BCA Capability Statement

Cessnock Hospital Redevelopment

Prepared for: HINSW

Our Ref: 23000347 | Issue date: 23 October 2024

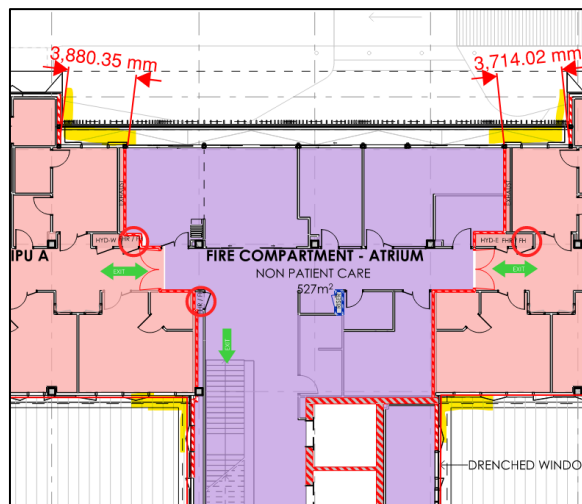
Link bridge must comply with C3D8 - separation from the existing building on site via fire wall construction and protection of openings. The protection is proposed only to one side via a performance solution.

Note the structure of the link bridge must also be documented to comply with the united building provisions of the BCA. i.e. the bridge must be supported from the new hospital and not the existing building.

Structural engineer shall verify the link bridge is independent of the existing building on site.
